November 02, 2018
ADDENDUM NO. 1

Northern Kentucky University

**Commonwealth Hall Renovations
NKU-16-19**

1
ASK 01

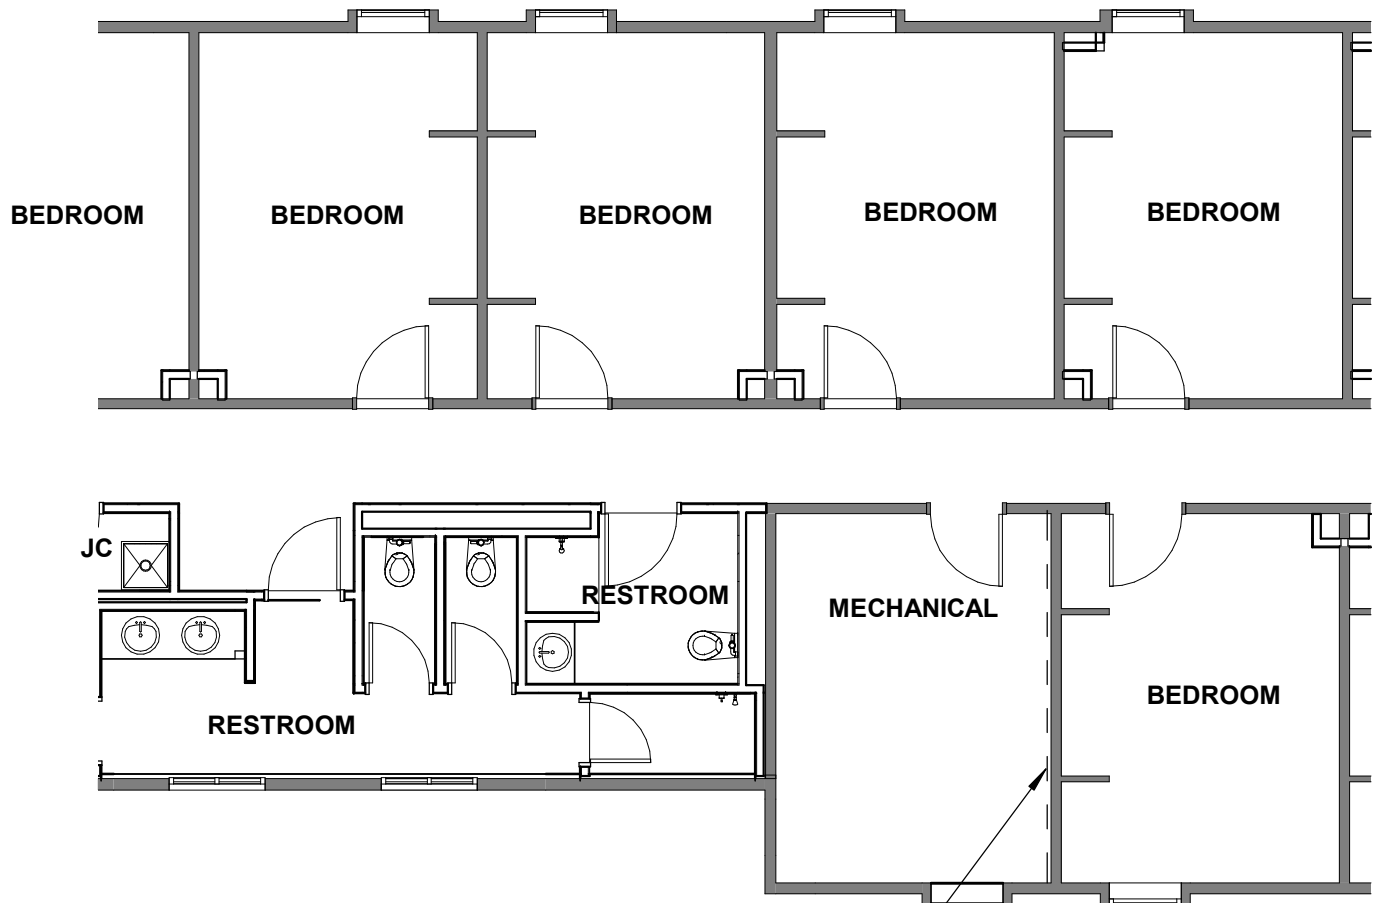
Item #2: Mechanical Room sound control

Install new gyp board, hat channels and acoustical sealant as shown in attached sketch ASK-01 in all three third floor mechanical rooms.

1 ASK-02 EPOXY FLOOR BASE DETAIL 12" = 1'-0"

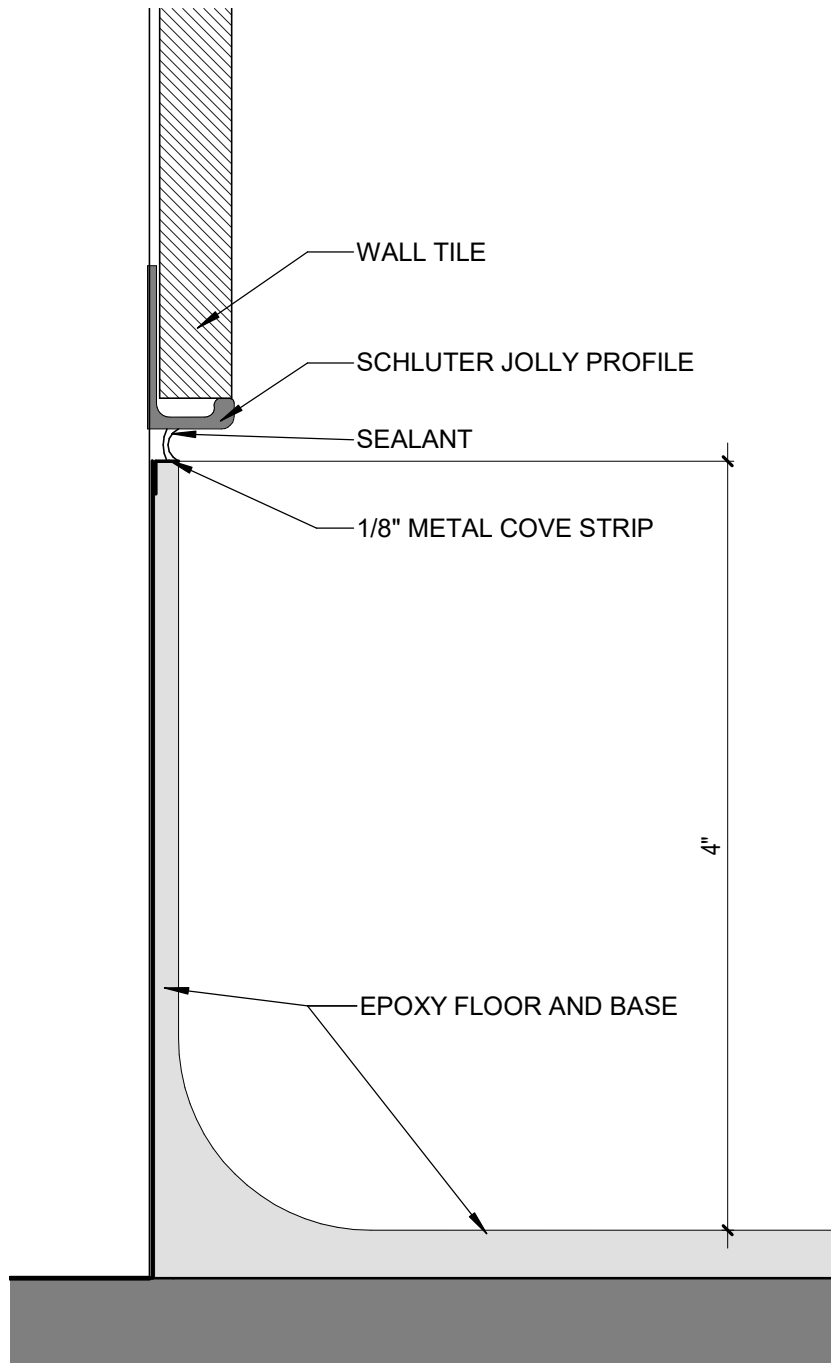
Question: Ref. A601, Specification 096723 Resinous Flooring. In Specification 096723-3.2-E, it calls for a 4" high integral base as part of the epoxy floor system. The elevations A601 inside of the restroom show wall tile all the wall to the floor. Please clarify this condition as well as provide a cut sheet section at the floor and walls in the restrooms.

Response: Where walls with wall tile and resinous floor intersect, utilize the detail shown in attachment ASK-02 which shows an integral epoxy base and wall tile that stops 4" above the floor.

A401

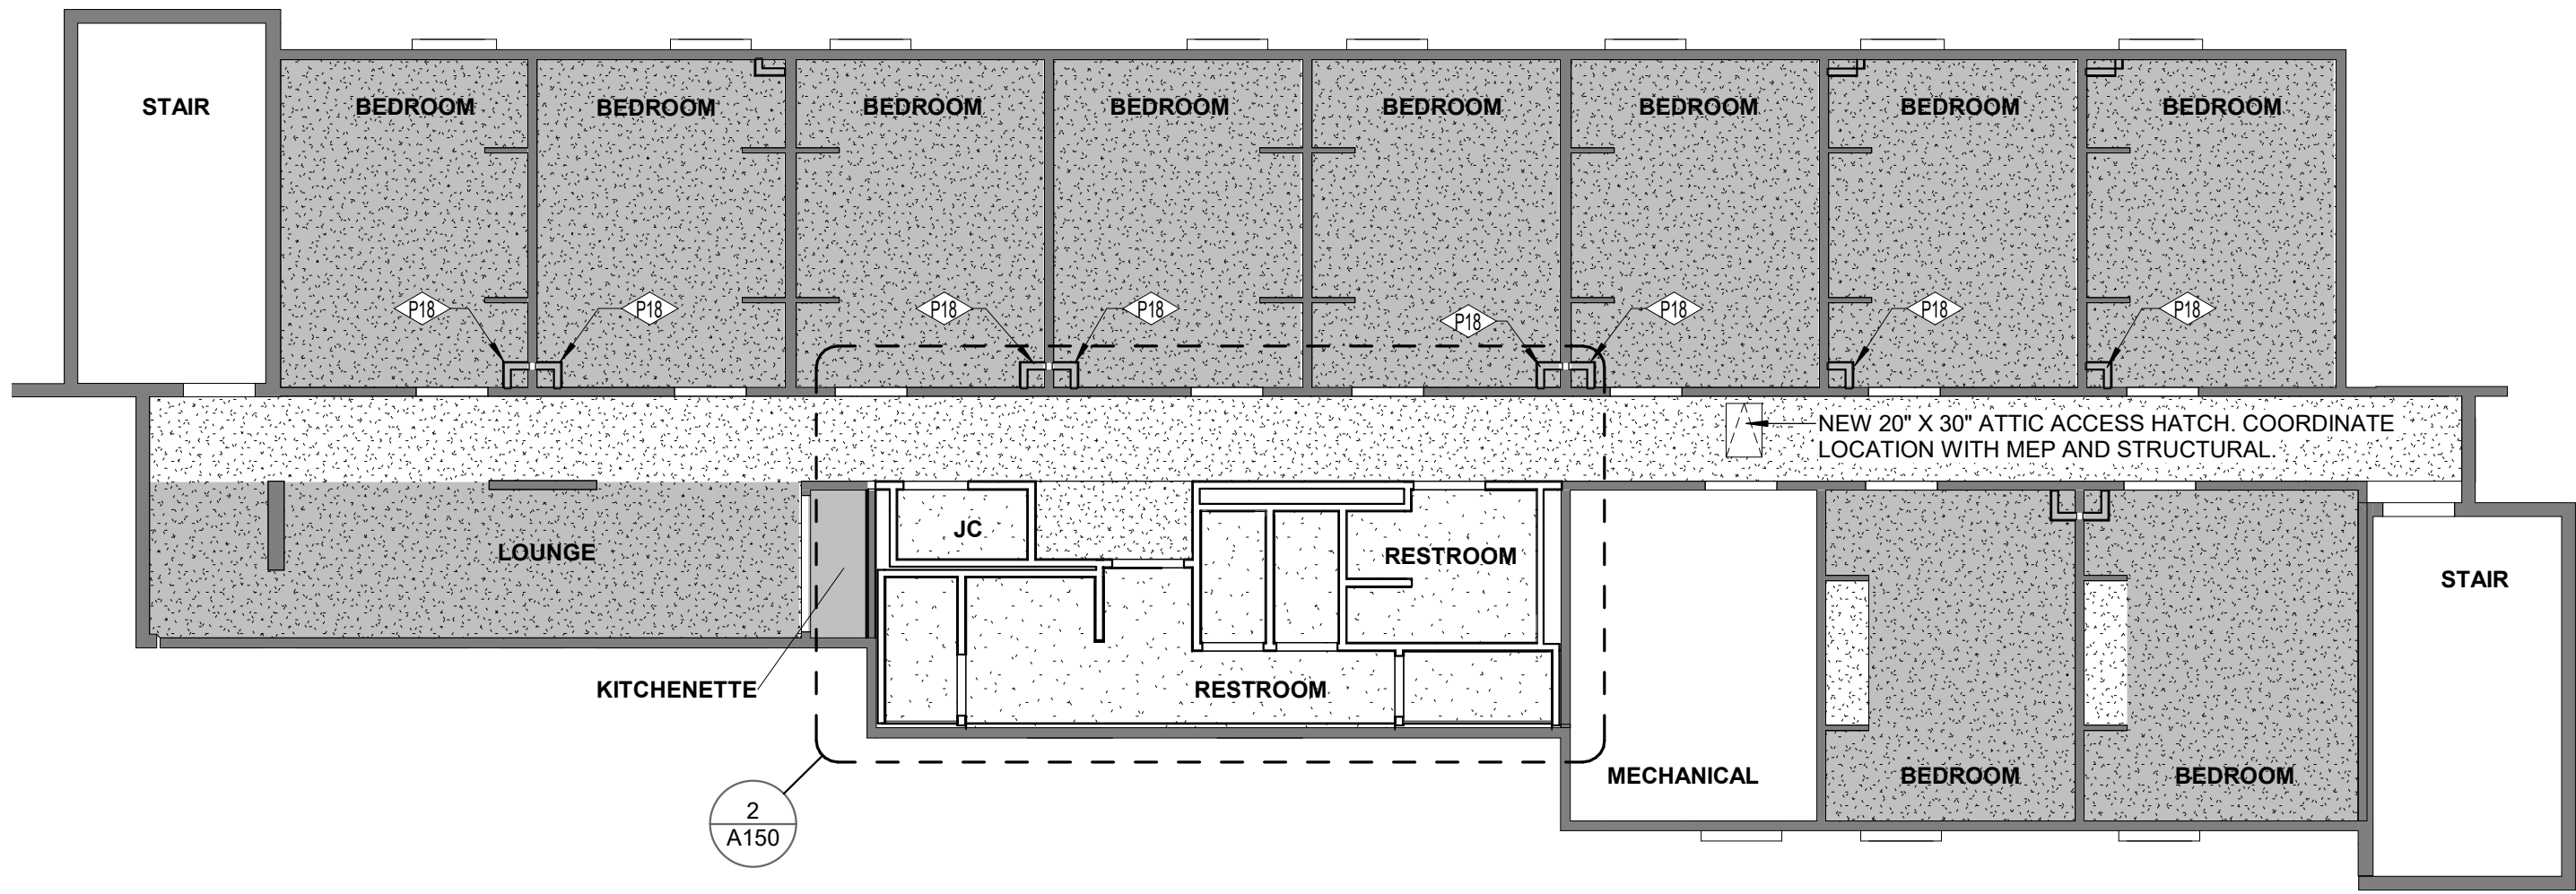
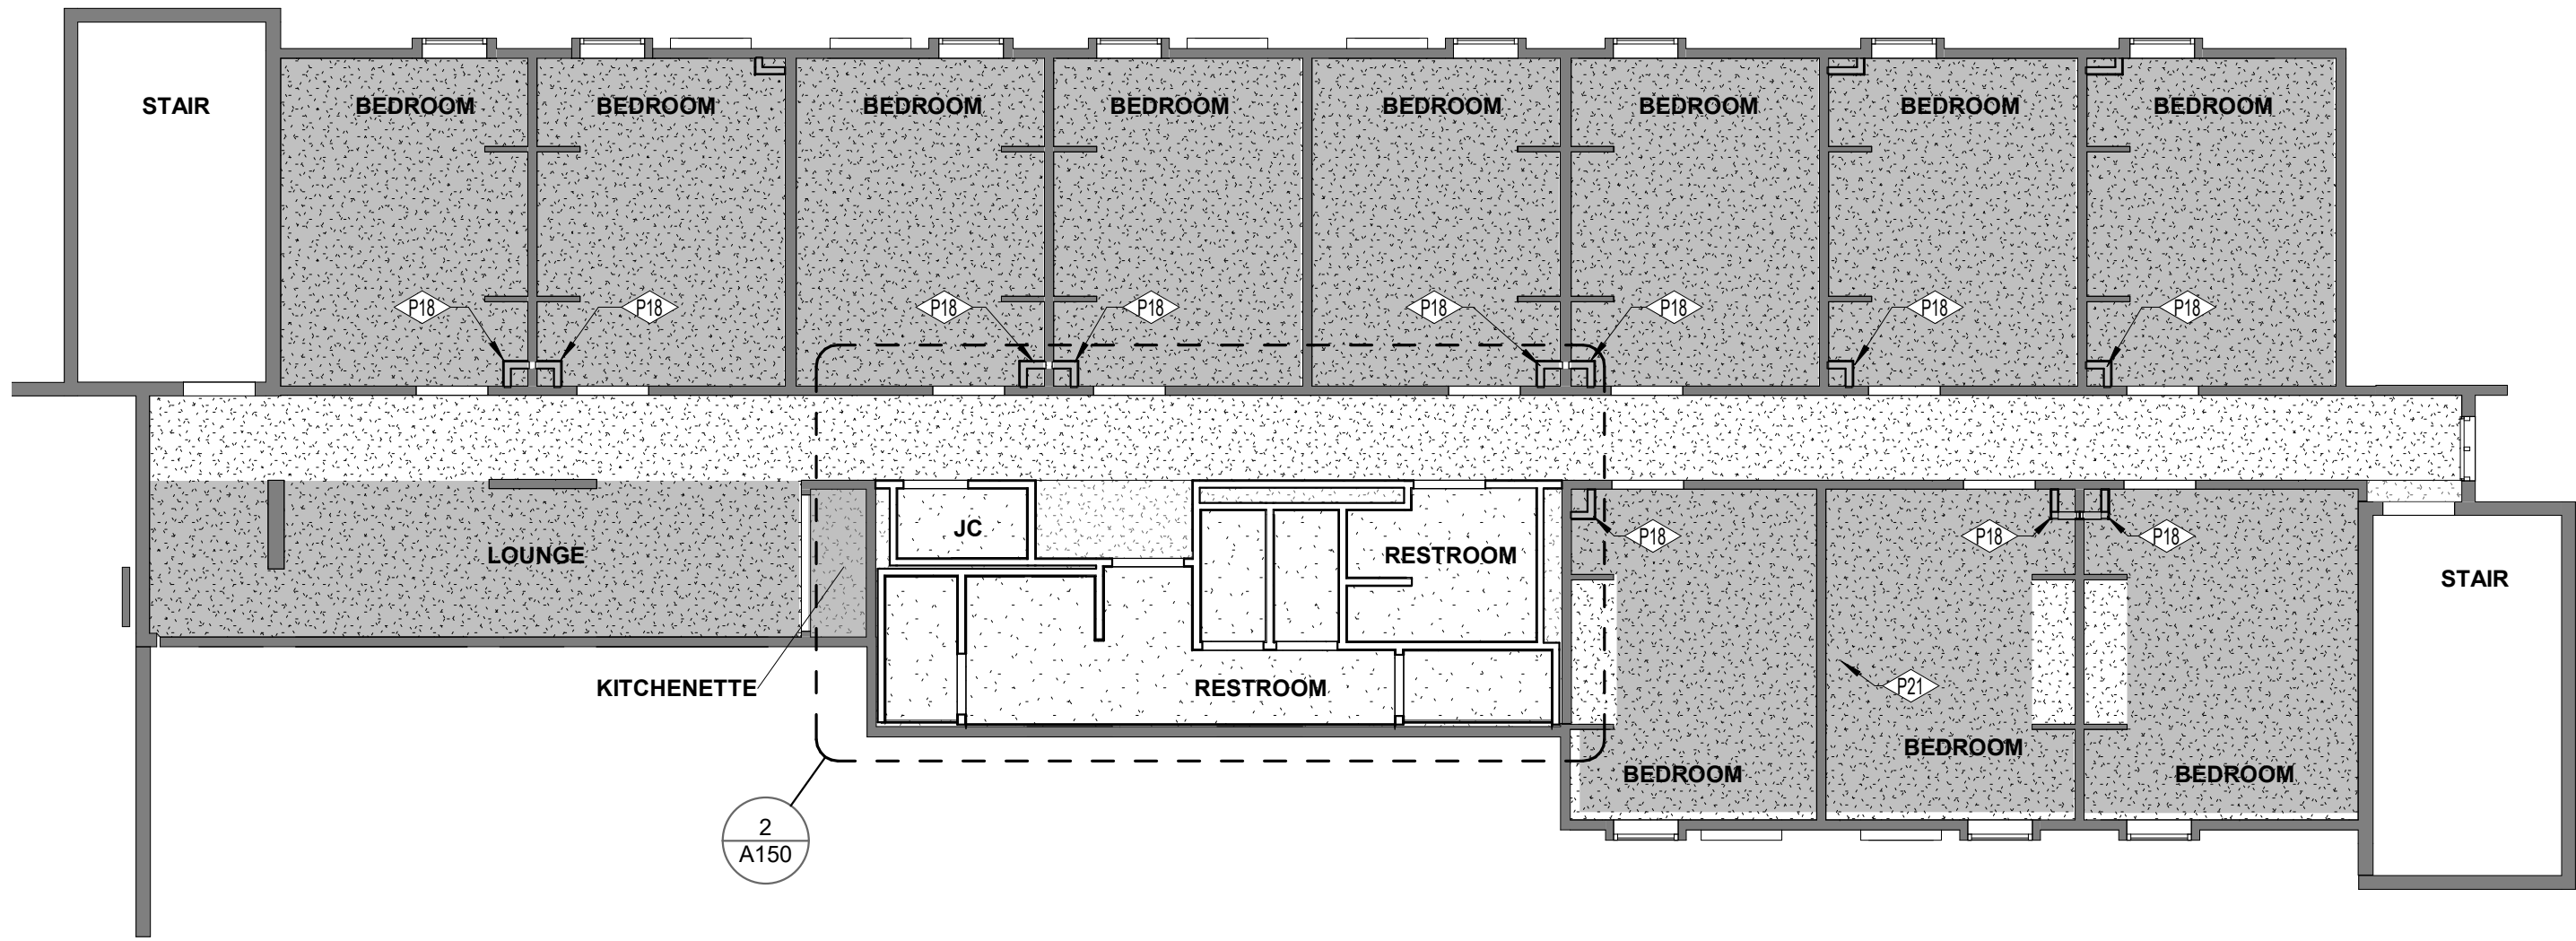
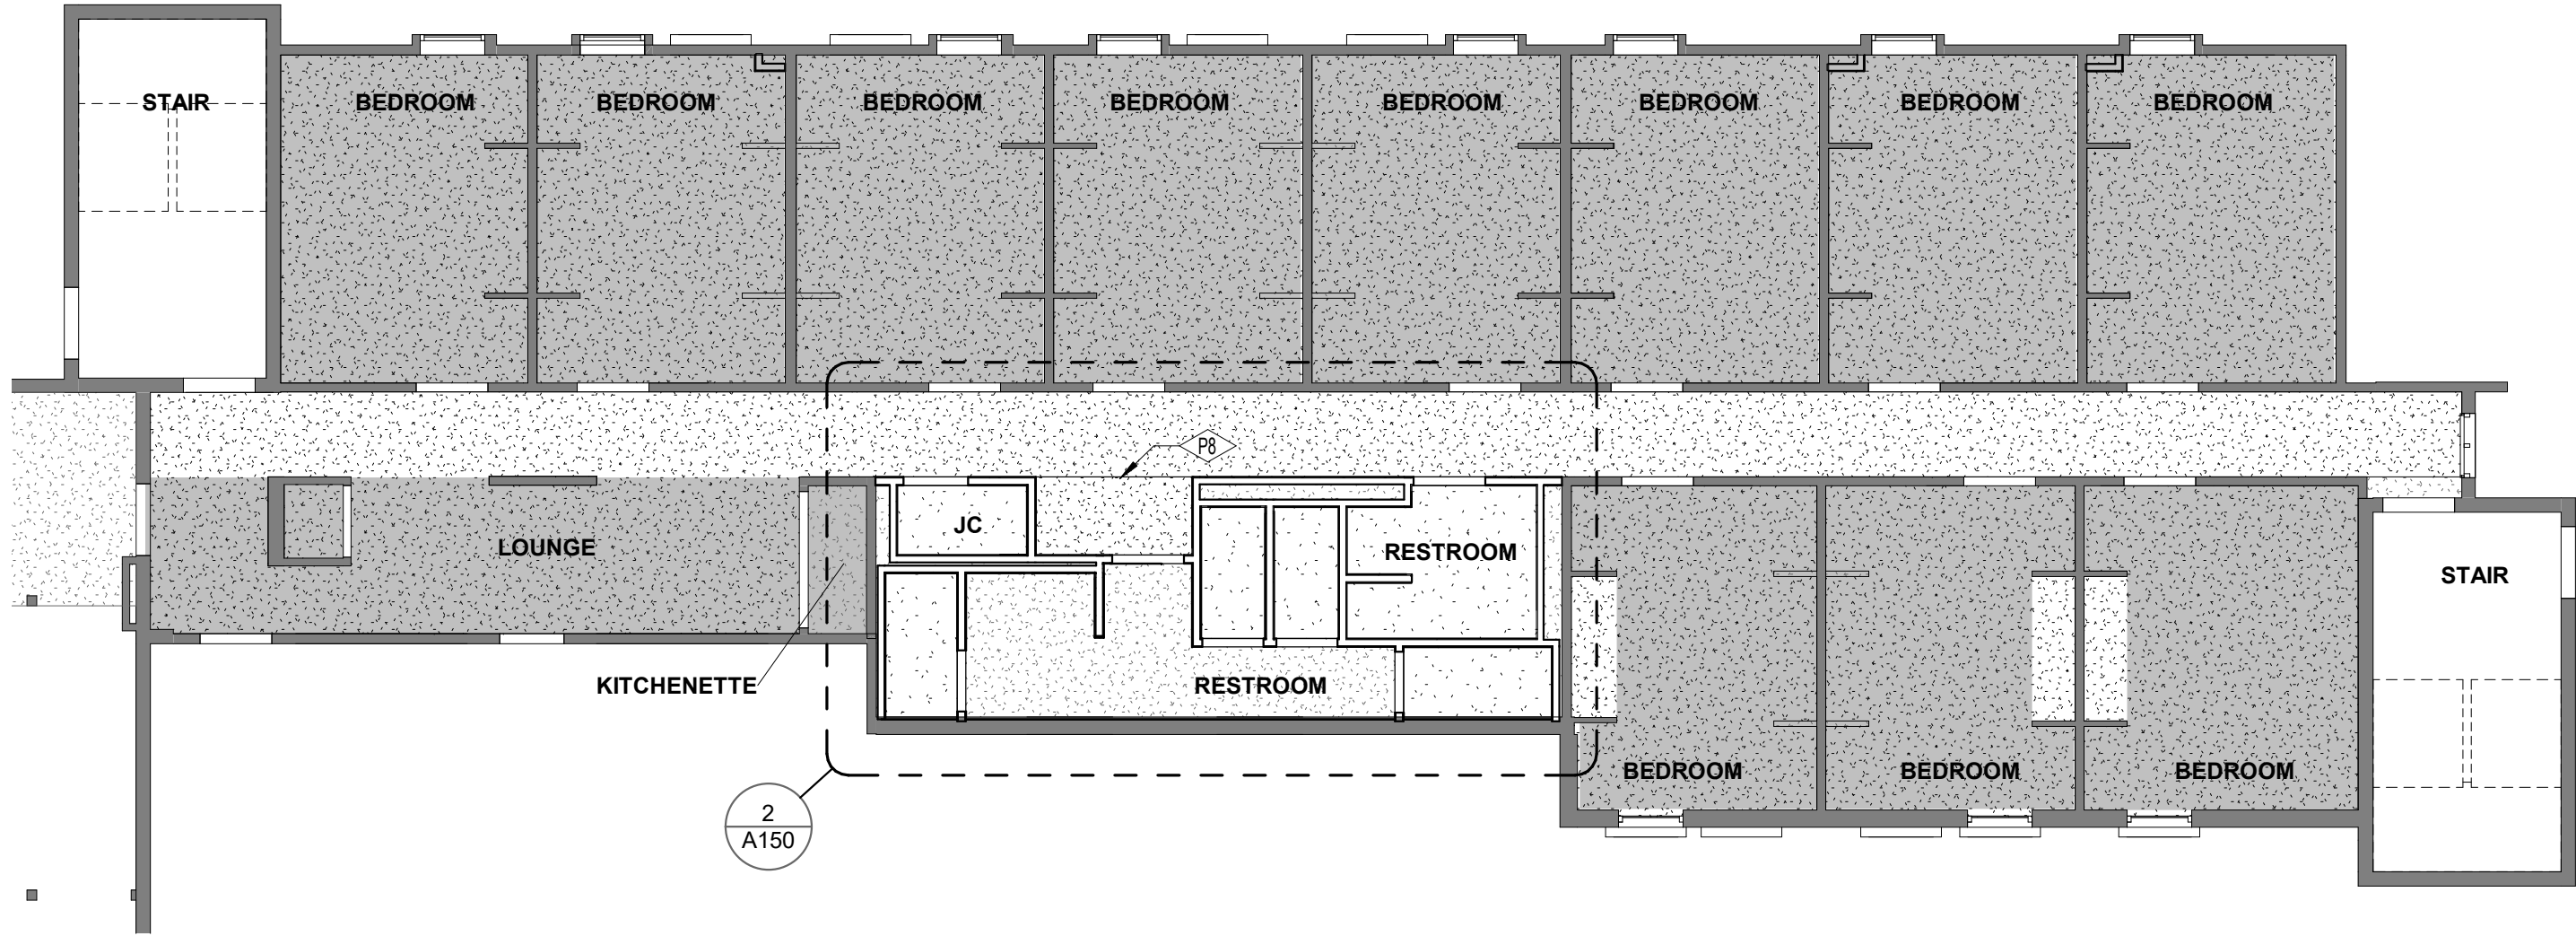
Item #10: SHEET A401

Sheet A401 is being reissued. The gray hatches to indicate existing ceilings did not show up correctly in the original drawings. This sheet shows the existing ceiling areas graphically.
